**ADDENDUM TO THE MILL AREA
REMOVAL ACTION WORK PLAN
CHEVRON QUESTA MINE
SUPERFUND SITE**

Revision 1

Prepared for
Chevron Mining Inc.
Questa, New Mexico

September 27, 2018

SHEET TITLE
EXISTING CONDITIONS AND 2018 EXCAVATION PLAN
C-1A
 SHEET C-1A OF 5

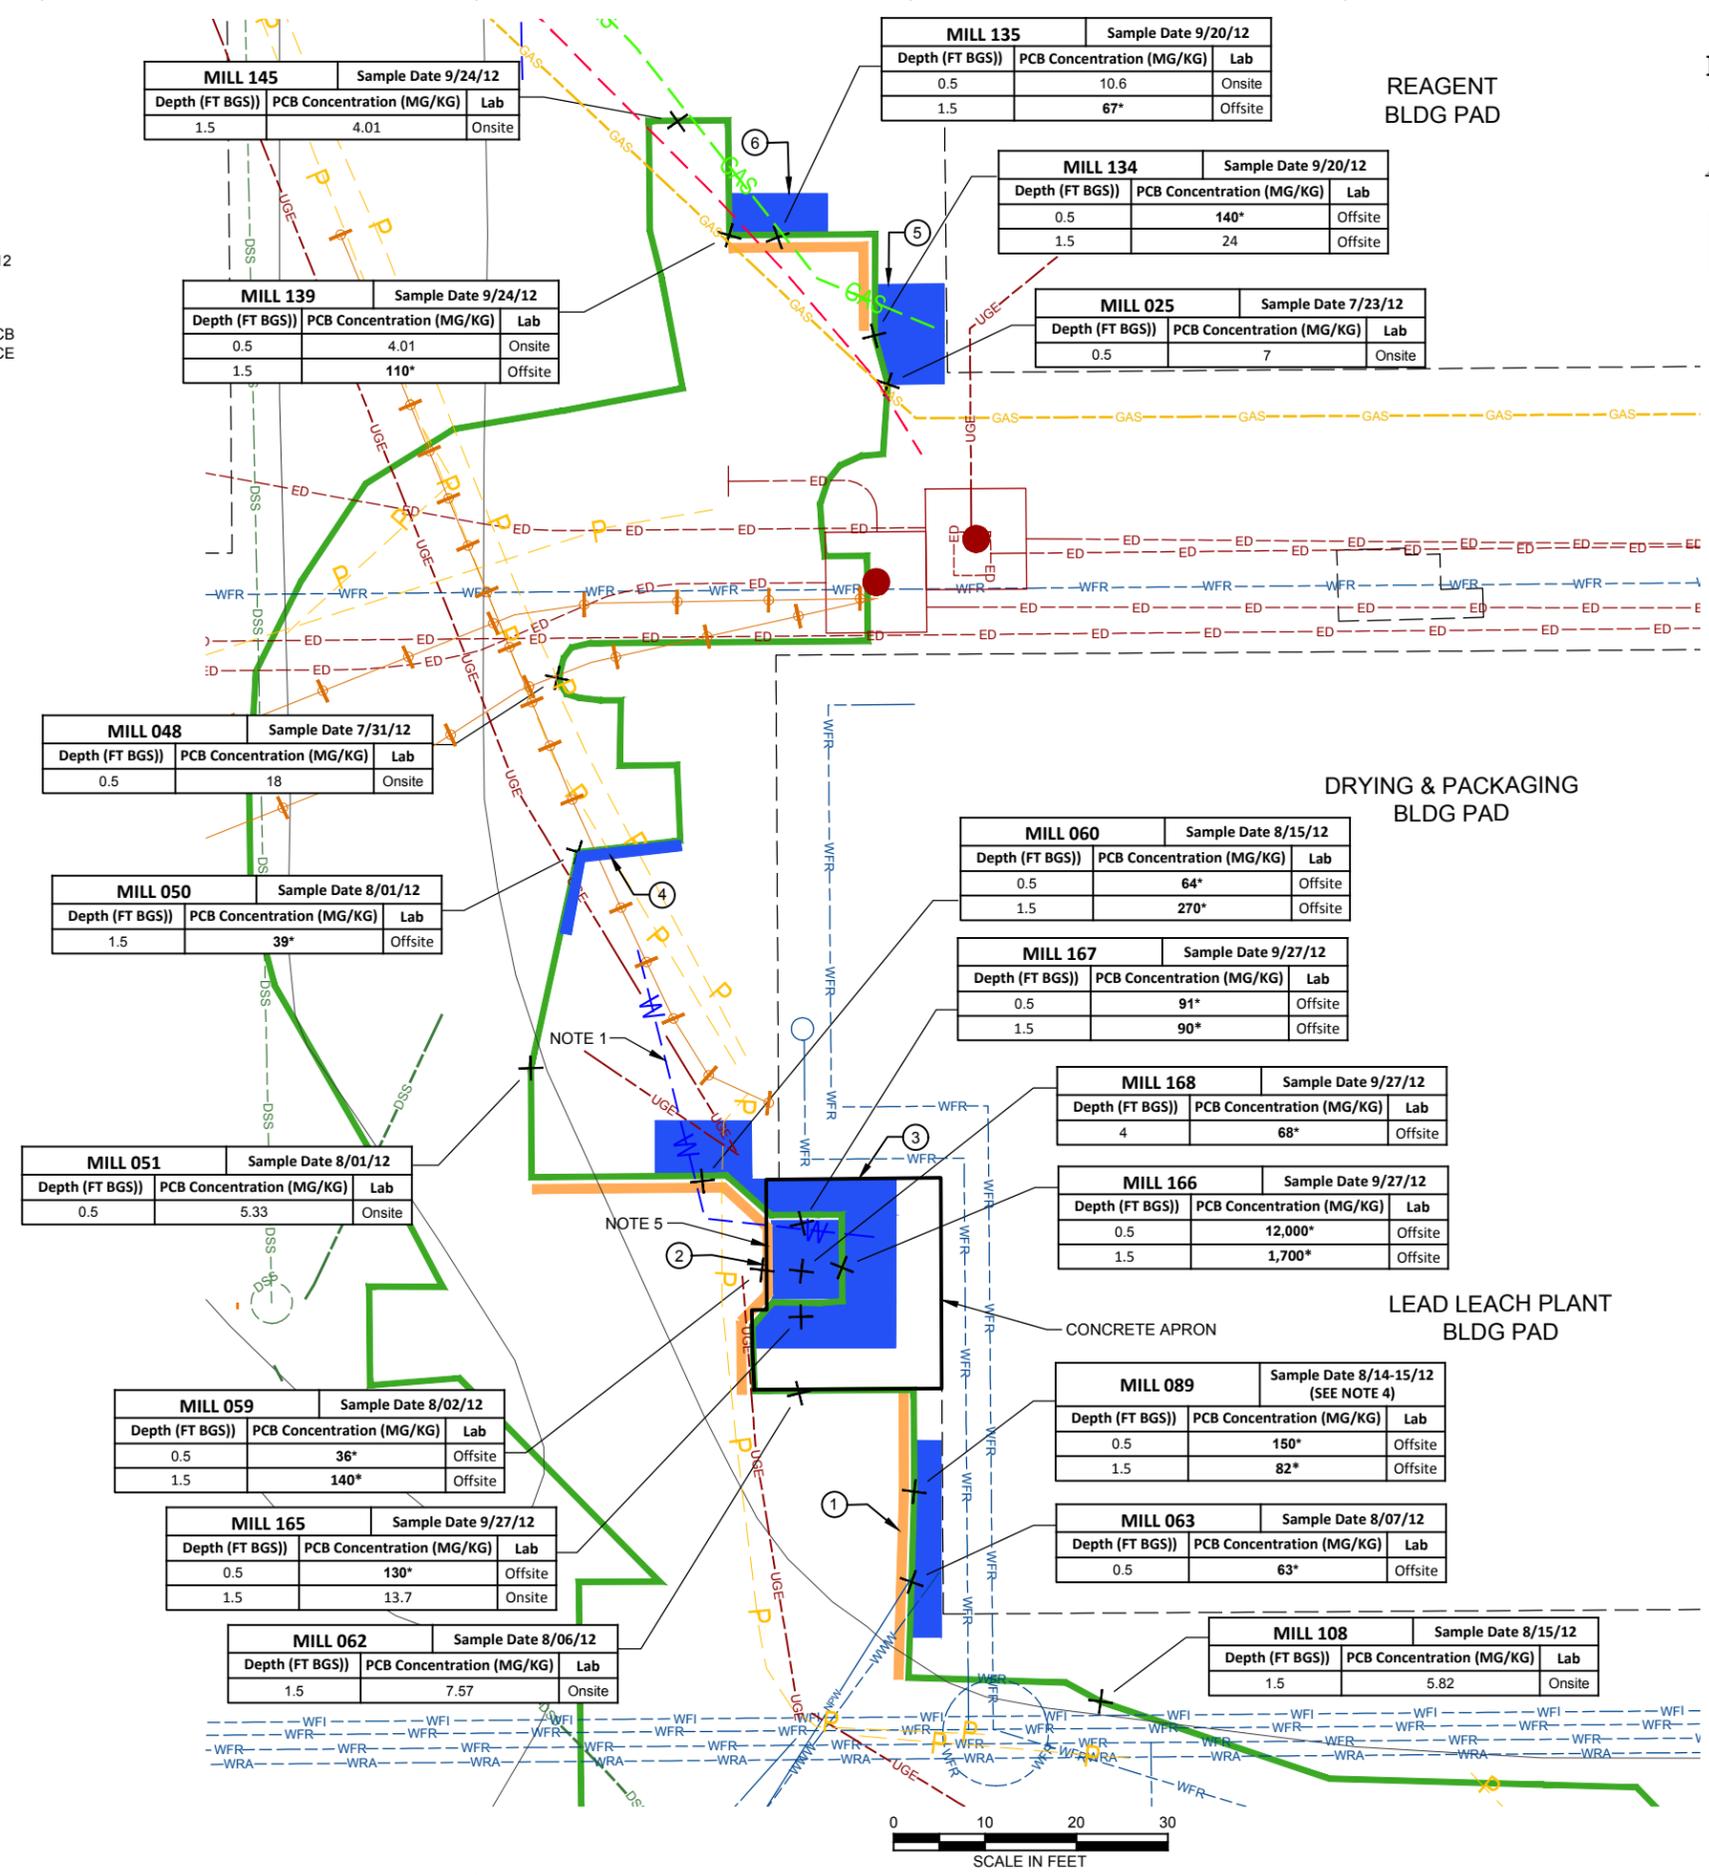
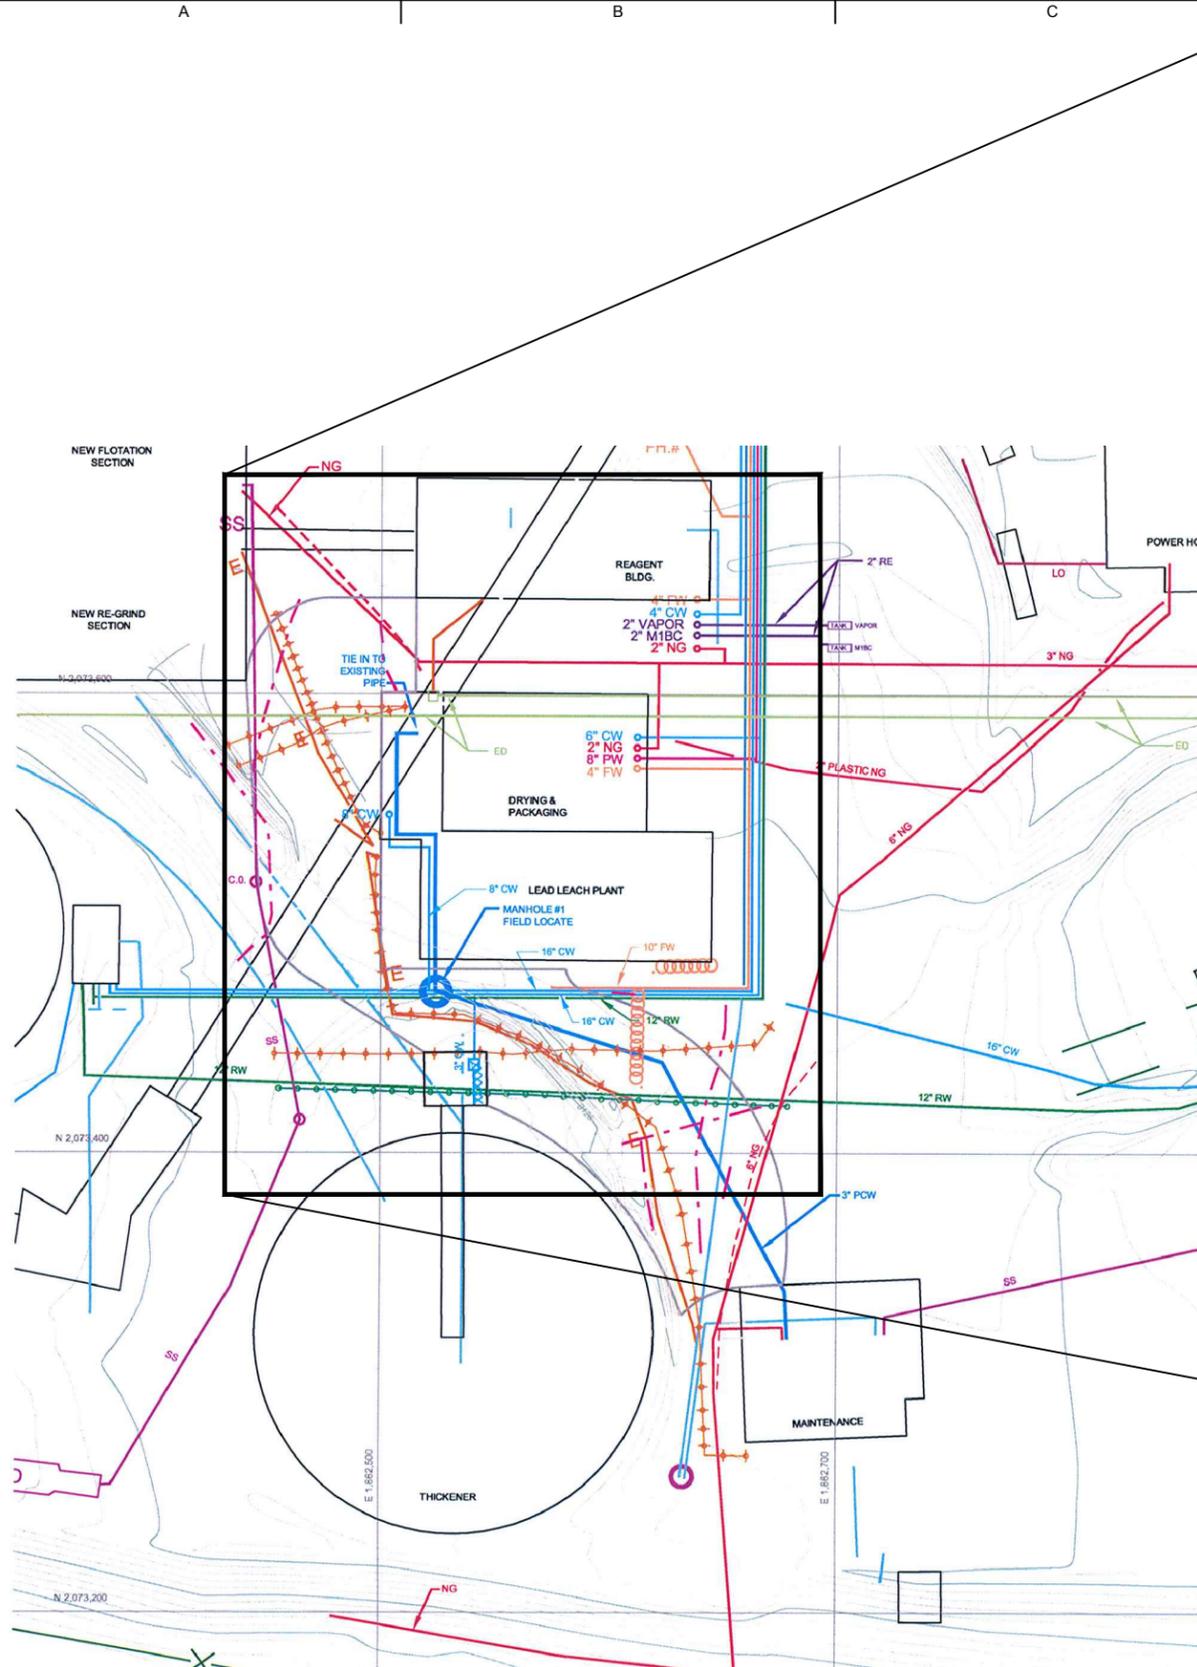
The PCB concentrations at sample locations Mill 063 and Mill 089 (Drawing C-1A) are \geq 50 mg/kg. Per the approved work plan (URS 2012a), the combined initial excavation for these 2 locations will be from approximately 5-ft to the South of sample location Mill 063 to approximately 5-ft to the north of sample location Mill 089 to a depth of approximately 3-ft bgs (target depth) and will extend to the foundation of the Lead Leach Plant (approximately 3 to 4 ft from the edge of the 2012 excavation).

The PCB concentrations at sample locations Mill 060, Mill 165, Mill 166, Mill 167, and Mill 168 (Drawing C-1A) are \geq 50 mg/kg. Per the approved work plan (URS 2012a), the combined initial excavation (Excavation Area 3) for these 5 locations will be from approximately 5-ft to the South of sample location Mill 165 to approximately 5-ft to the East of sample location Mill 166, extending to the foundation of the Drying & Packaging Building (approximately 4 ft from the northern edge of the 2012 excavation at sample location Mill 167) and to the boundary of the 2012 excavation to the west of sample locations Mill 167 and Mill 165 to a depth of approximately 3 ft bgs. This excavation will also extend approximately 5-ft to the East, North, and West of sample location Mill 060 and approximately 3 ft bgs deep. In the area around sample location Mill 168 (Excavation Area 2) bounded by sample location Mill 059 on the west and the extents of the 2012 excavation on the remaining sides, a portion of the concrete apron was previously removed, and impacted soils were excavated to approximately 4 ft bgs.

The PCB concentration at sample location Mill 050 (Drawing C-1A) is ≥ 25 mg/kg. Per the approved work plan (URS 2012a), the initial excavation will be approximately 10 ft to the east and 10 ft to the south of sample location Mill 050 along the footprint of the 2012 excavation, a minimum of 1 ft of impacted soil to the south and east of the 2012 excavation boundary should be removed to an approximate depth of 3 ft bgs.

The PCB concentration at sample location Mill 134 (Drawing C-1A) is ≥ 50 mg/kg. Per the approved work plan (URS 2012a), the initial excavation will be from approximately 5-ft to the South and North of sample location Mill 134, extending East to the foundation of the Reagent Building (approximately 5 to 7 ft from the footprint of the 2012 excavation) and to a depth of approximately 3 ft.

To the northwest of sample location Mill 134, the PCB concentrations at sample locations Mill 135 and Mill 139 are ≥ 50 mg/kg. Per the approved work plan (URS 2012a), the initial excavation will be approximately 5-ft to the East and north of sample location Mill 135 extending West to sample location Mill 139 along the footprint of the 2012 excavation and to a depth of approximately 3 ft.
